CITY OF WASHINGTON, ILLINOIS

City Council Communication

Agenda Item: Trails Edge 9&10 Drainage

ISSUED
 08-04-2021 CONCEPTUAL STORMWATER EXHIBIT

CONCEPTUAL STORMWATER EXHIBIT

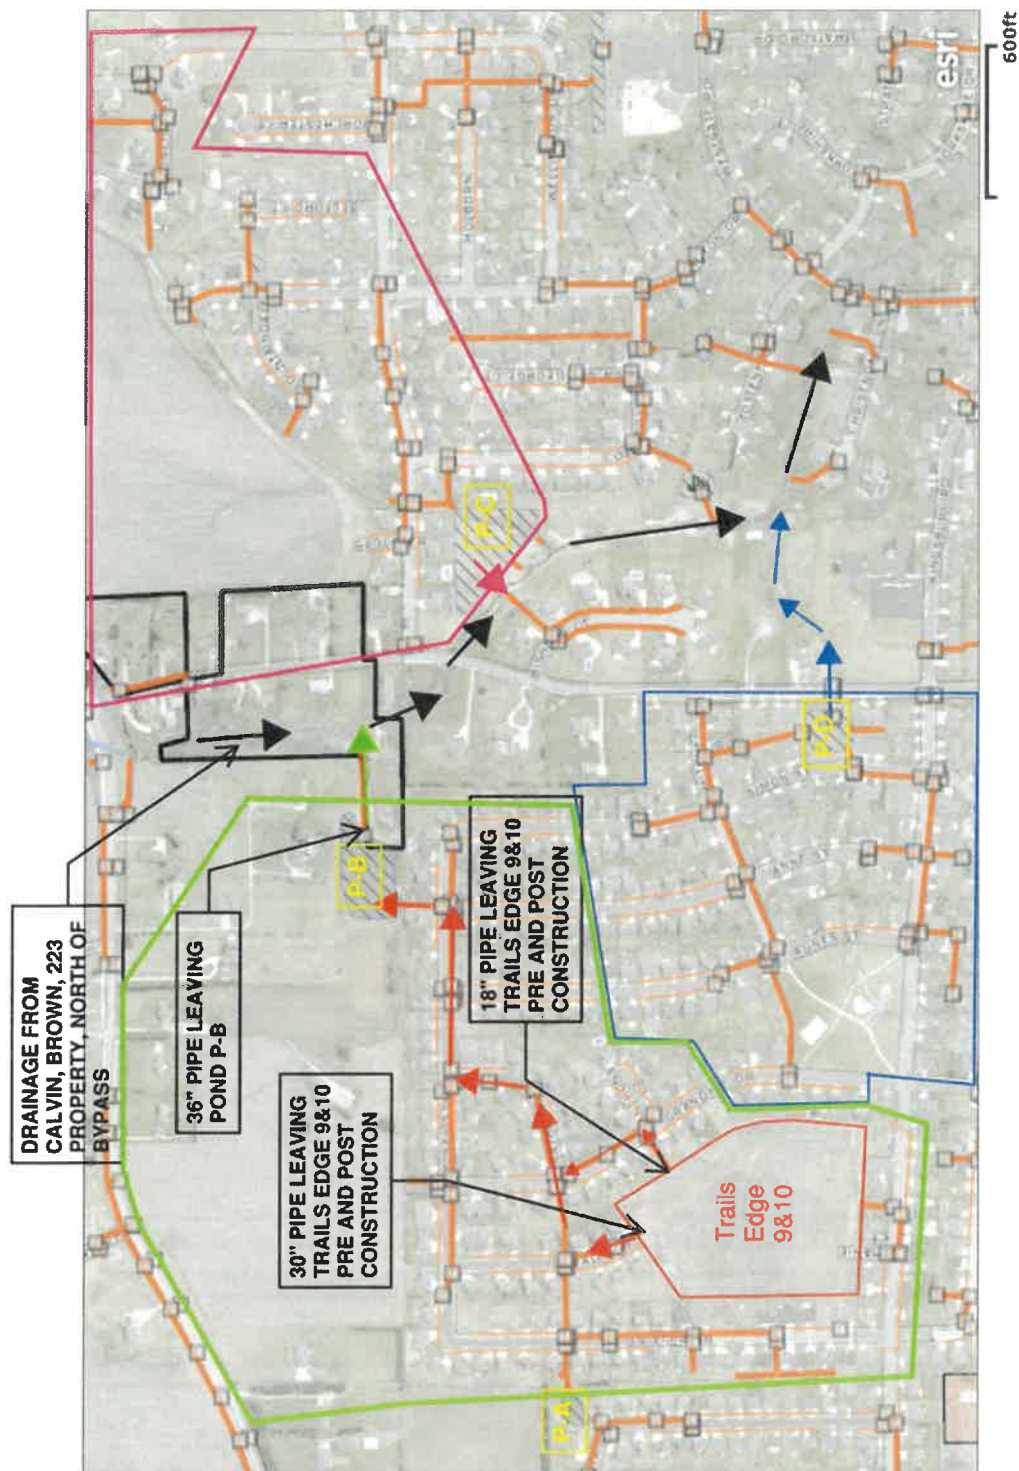
Comments made during the August 2 City Council meeting expressed concern the Proposed Development will negatively impact stormwater management in the Trails Edge area. The Developer met with City staff on August 4 to discuss potential additional stormwater control measures beyond the City Code requirements. The Developer proposes to modify the Proposed Development to include a surface drainage easement in the Proposed Development that will serve as temporary detention (see attached depiction of the preliminary drainage easement).
